PD Inrush 33.3.7.3 cleanup v120

Info (not part of baseline)

Timing overview:

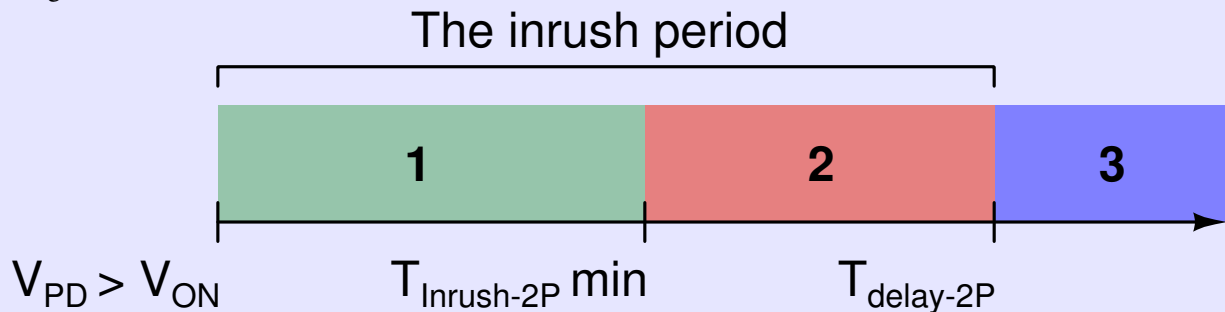
What are the real requirements on PDs in each of these periods ?

1. This is the time between the crossing of V_{On_PD} and $T_{Inrush-2P \text{ min}}$ later. There are no specific requirements for PDs during this time. Inrush is limited by the PSE during this period.

2. This is the time between $T_{Inrush-2P \text{ min}}$ and $T_{delay-2P}$. PDs need to make sure they have taken control of the input current and restrict it to less than I_{Inrush_PD} and I_{Inrush_PD-2P} . This requirement also encapsulates that a PD may not switch to a high power state (it cannot do so without violating I_{Inrush_PD} and I_{Inrush_PD-2P}).
In addition there is a quirk that assigned Class 1,2 and 3 PDs need to take into account. They are required to restrict their power consumption below P_{Class_PD} or P_{Class_PD-2P} because the PSE may already enforce Class power at $T_{Inrush-2P \text{ min}}$.

3. Finally, this is the time after $T_{delay-2P}$. After this time the PSE is guaranteed to be in `POWER_ON` and the PD needs to follow the normal rules of `MDI_POWER2`.
